This Service Information bulletin supersedes S.I. B11 04 03 **dated July 2005**.

NEW **Noise Complaints From Mechanical Alternator Belt Tensioners**

E39 5 Series and E36 Z3 with M54 engine through end of production

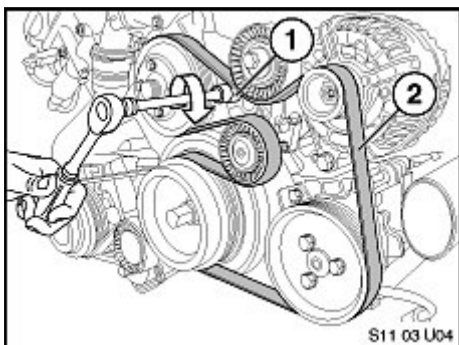
Customer complains of the rattling or screeching noises upon cold start of the engine. The noise will usually dissipate after the engine warms up. Cold weather aggravates the condition. Noise comes from the area of a mechanical alternator belt tensioner.

ON A CUSTOMER COMPLAINT BASIS ONLY, and only after the original mechanical belt tensioner in the vehicle has failed, replace the mechanical tensioner with the hydraulic style tensioner and install a new Ribbed V-Belt.

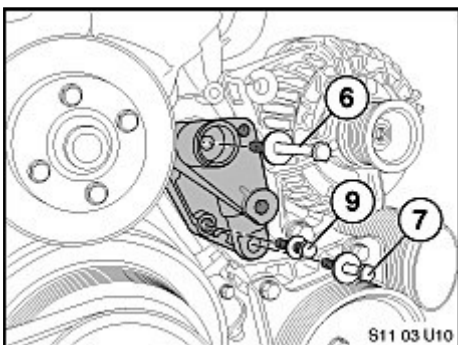
Assemble new tensioner components as shown. Install bolt 8 (P/N 07 11 9 913 111) in position shown. Insert bolt 6 (07 11 9 901 785) and 7 (07 11 9 912 652) in preparation for installation on engine.

Install the assembly on the engine. Note: Hydraulic tensioner is held in place by 3 bolts. Upper bolt 6 (07 11 9 901 785) lower bolt 7 (07 11 9 912 652) and left side bolt 9 (07 11 9 913 111)

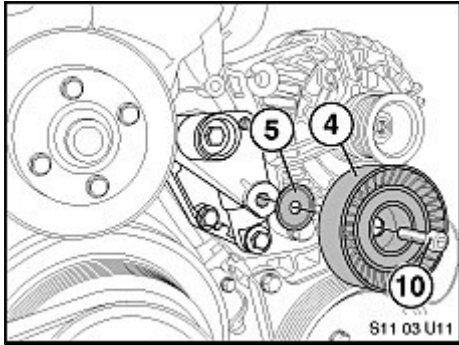
Install tensioner pulley (4) taking care to position the mudguard (#5) correctly. The dished portion faces to

the front.
